Westinghouse Revised Thermal Design Procedure  
Instrument Uncertainty Methodology  
for Wisconsin Electric Power Company  
Point Beach Units 1 & 2  
(Fuel Upgrade & Uprate to 1656 Mwt - NSSS Power)

Attachment 6 – Marked up Technical Specification Changes

**Attachment 6 – Marked up Technical Specifications for implementation of the 422V+ fuel assemblies at Point Beach Nuclear Plant Units 1 and 2**

Included in this attachment are the marked-up Technical Specifications indicating the proposed changes necessary for incorporation of the 422V+ fuel assemblies at PBNP. These changes are discussed in detail in Attachment 1 of this submittal. Also included in this attachment is a clean copy of the Technical Specification pages with the changes incorporated.

Figure 15.2.1-1 \*  
 POINT BEACH NUCLEAR PLANT UNITS 1 AND 2\*  
 REACTOR CORE SAFETY LIMITS

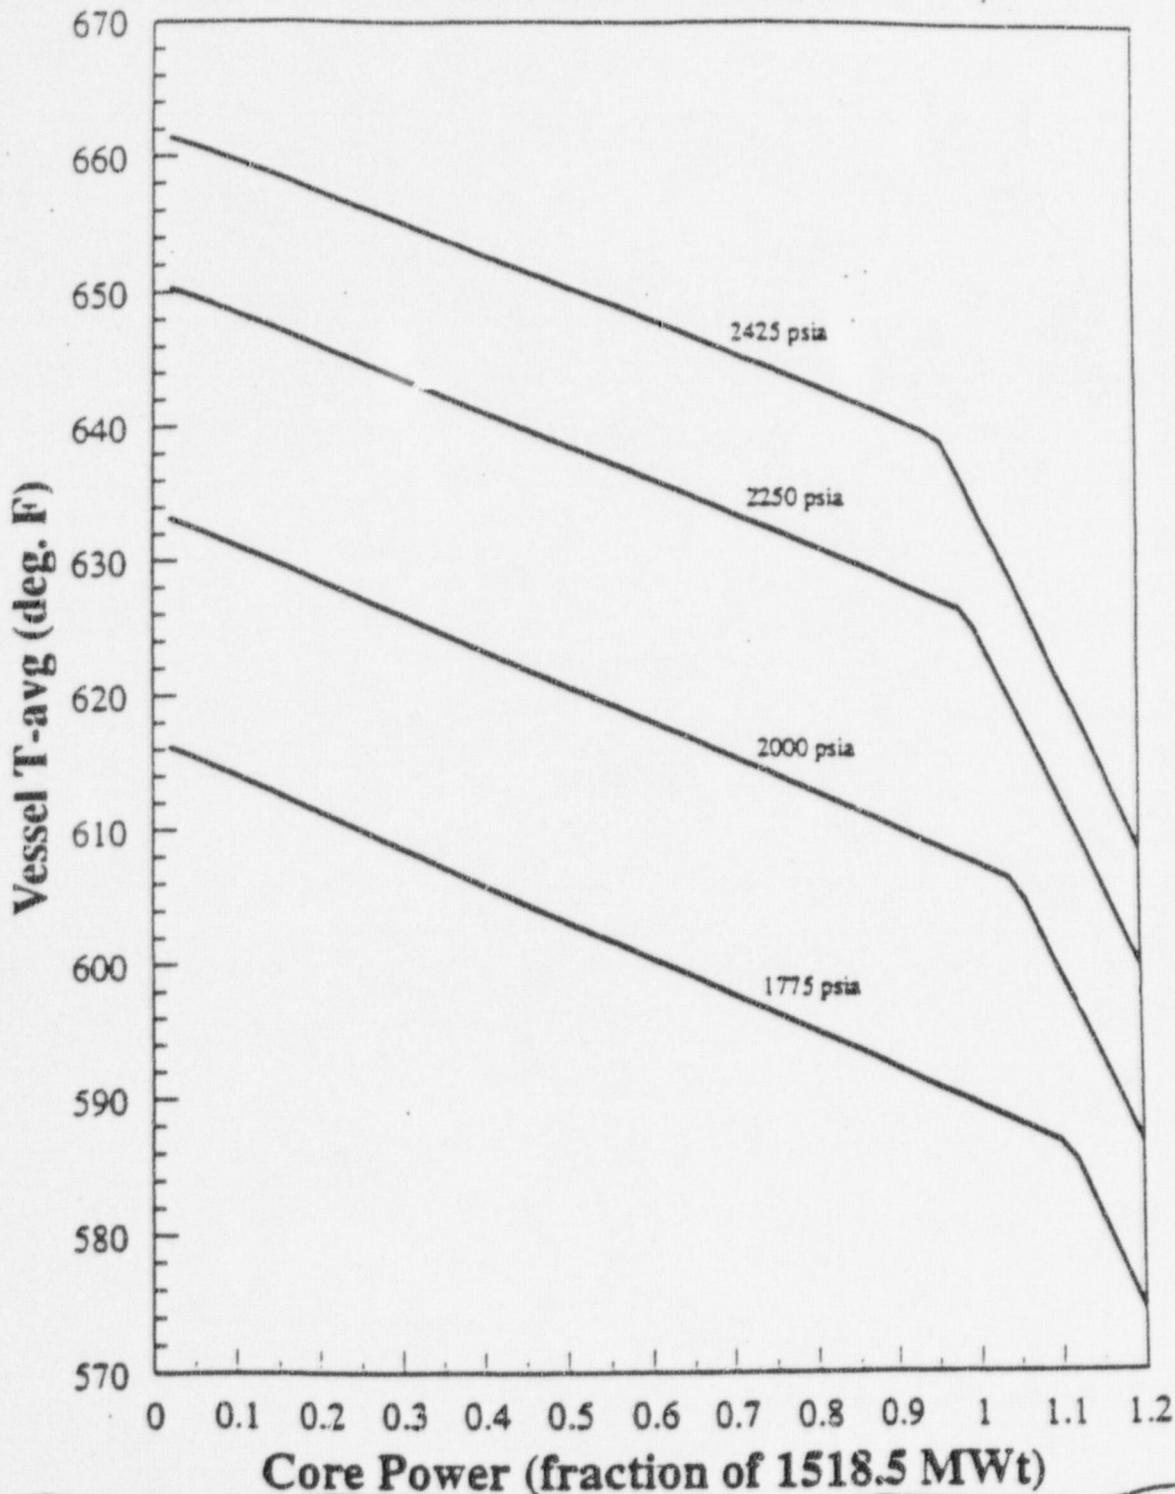
\* This figure applies to Unit 2 following U2R22 and to Unit 1 following U1R24. Prior to U1R24, Figure 15.2.1-2 applies to Unit 1.

\* This figure applies to core reloads with any combination of OFA and upgraded OFA fuel assemblies

Figure 15.2.1-2\*  
REACTOR CORE SAFETY LIMITS  
POINT BEACH UNIT 1

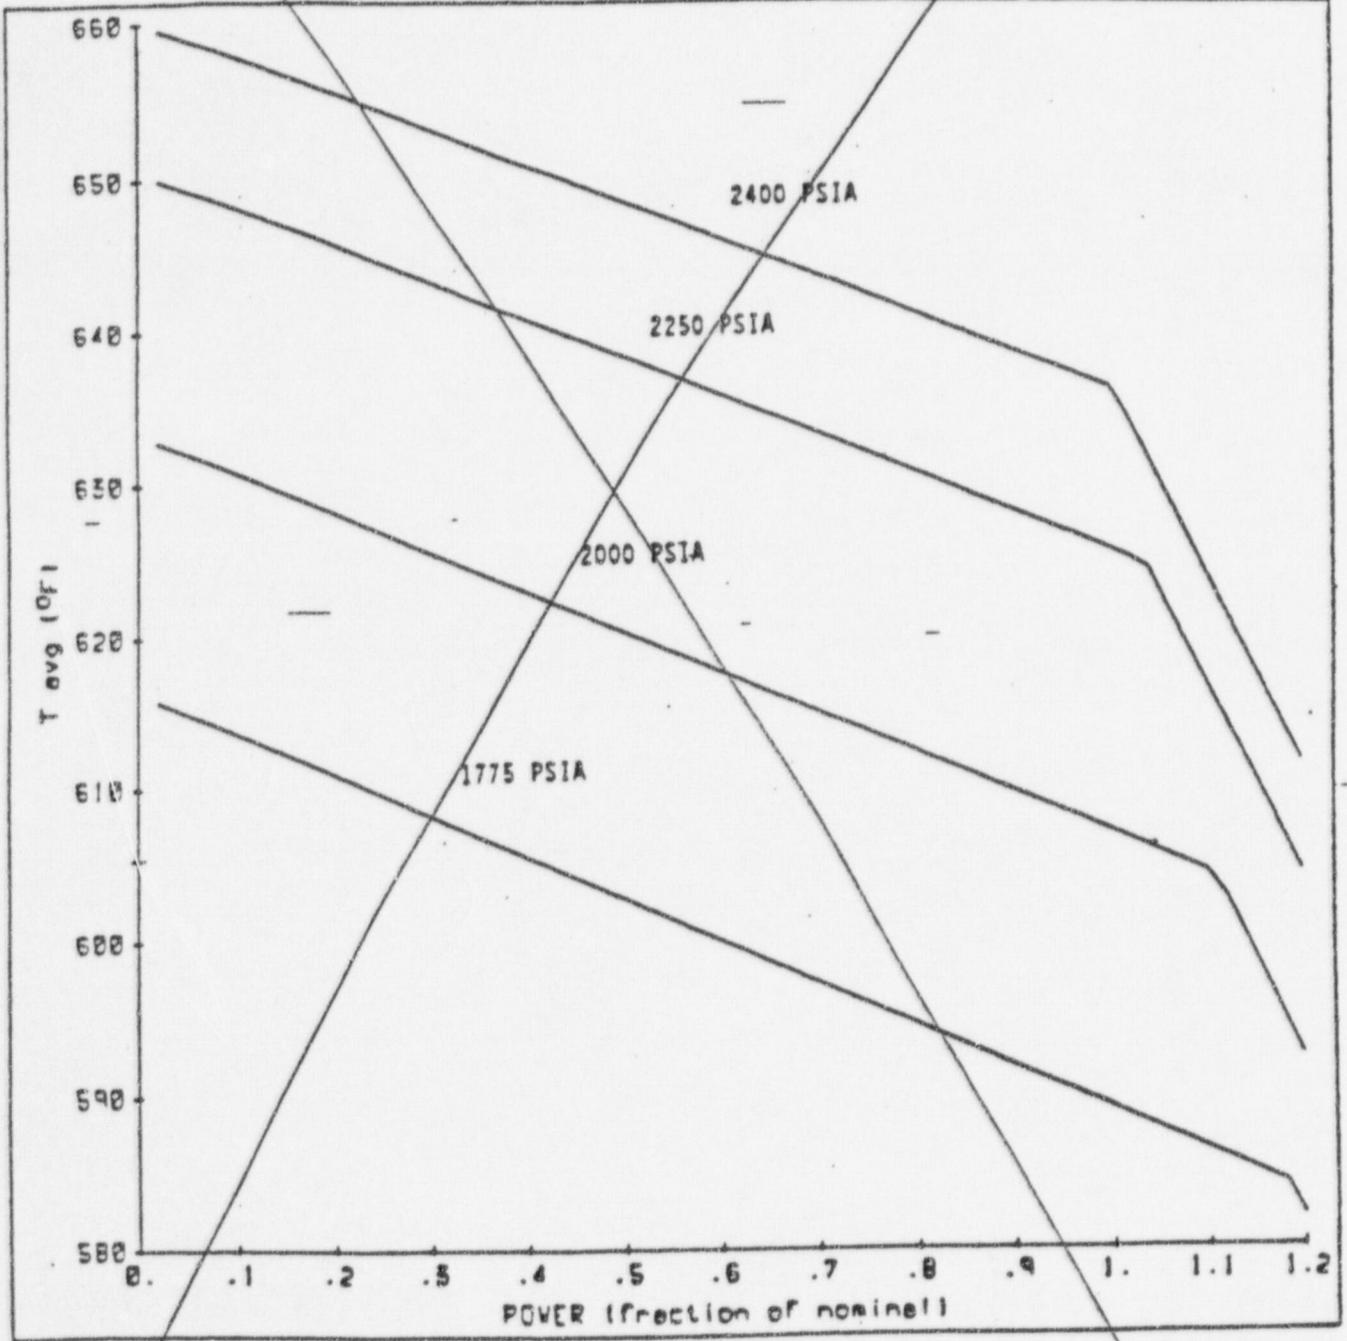
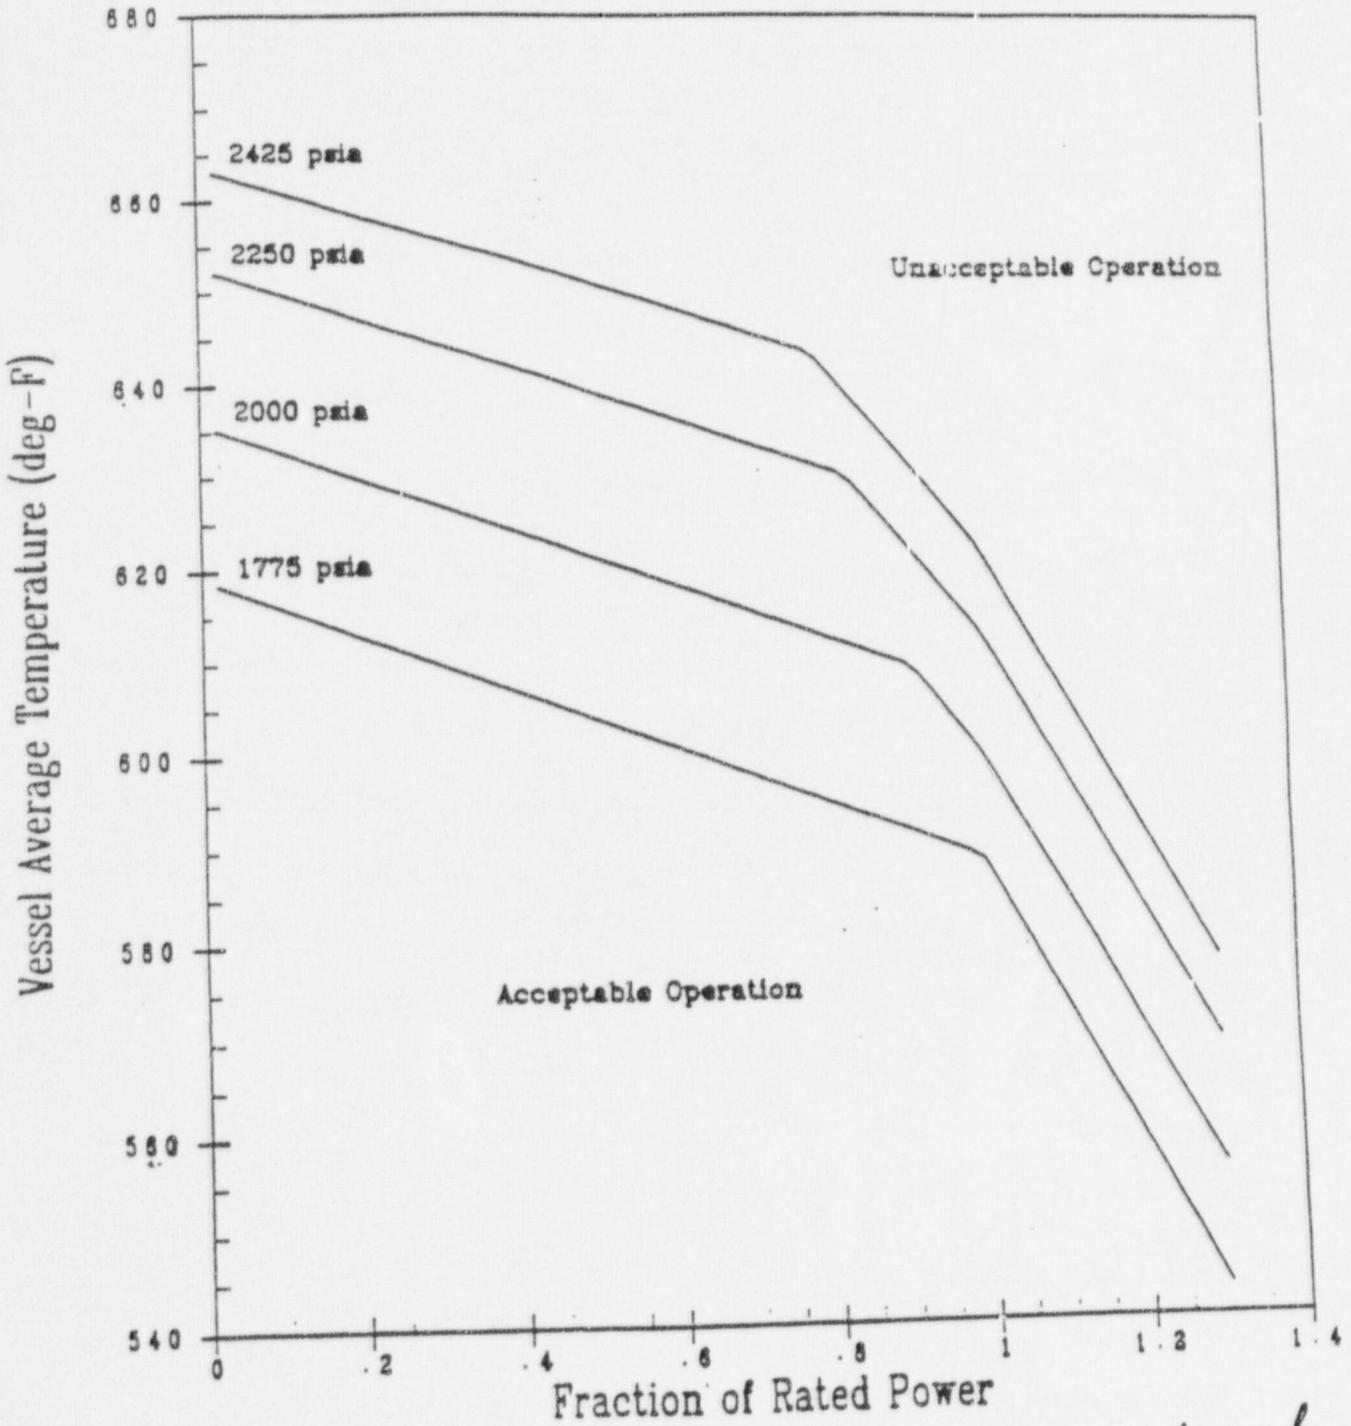
Replace with Insert 1

\* This figure applies to Unit 1 prior to U1R24. Following U1R24, Figure 15.2.1-1 applies to Unit 1.

Insert 1

\* This figure applies to core reloads with any combination of 422V + fuel assemblies, burned OFA and burned upgraded OFA fuel assemblies, or a full core of 422V + fuel assemblies

FIGURE 15.3.10-3A

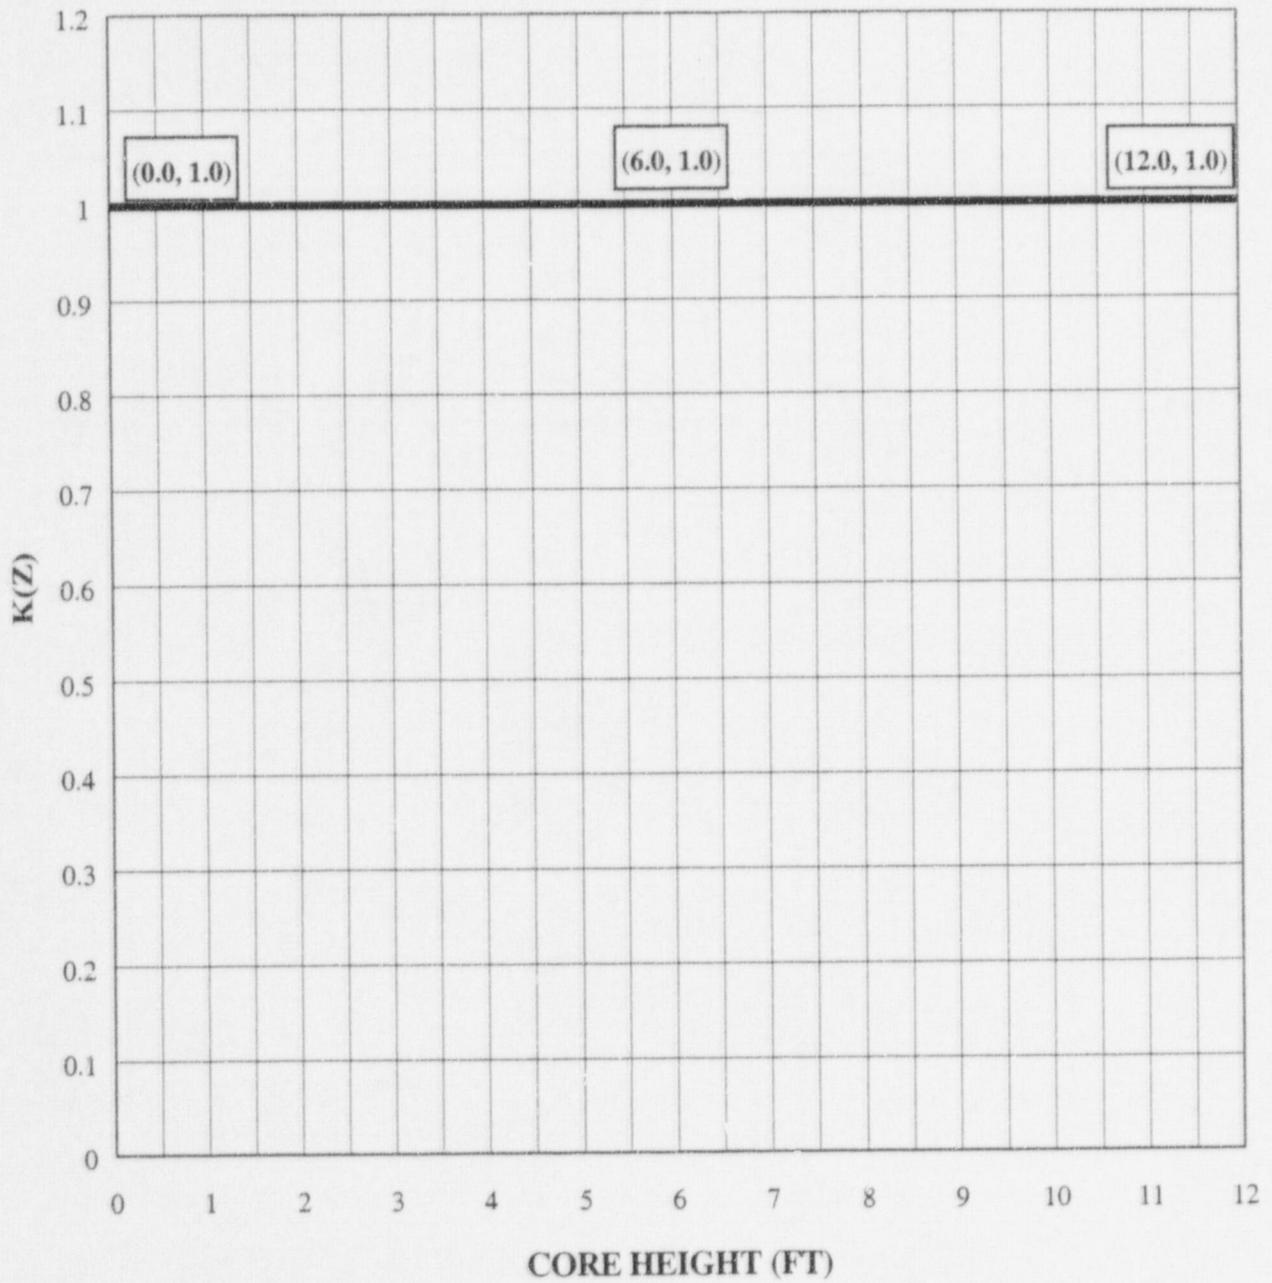
As a result of the increased peaking factors allowed by the new 422V+ fuel, a new column was added to TS 15.3.10.E.1.a. The full power  $F_{\Delta H}^N$  peaking factor design limit (radial peaking factor) for 422V+ fuel will increase to 1.77 from the 1.70 value for the OFA fuel. The maximum  $F_Q(Z)$  peaking factor limit (total peaking factor) for 422V+ fuel will increase to 2.60 from the 2.50 value for the OFA fuel. The OFA fuel design will retain the current  $F_{\Delta H}^N$  and  $F_Q(Z)$  peaking factors of 1.70 and 2.50, respectively. In addition, the  $K(Z)$  envelope for the new 422V+ fuel was modified and a new TS figure 15.3.10-3a was developed and inserted in the Technical Specifications. The  $K(Z)$  envelope in TS Figure 15.3.10-3 remains for the OFA fuel.

For OFA and Upgraded OFA Fuel and Figure 15.3.10-3a for 422V Fuel
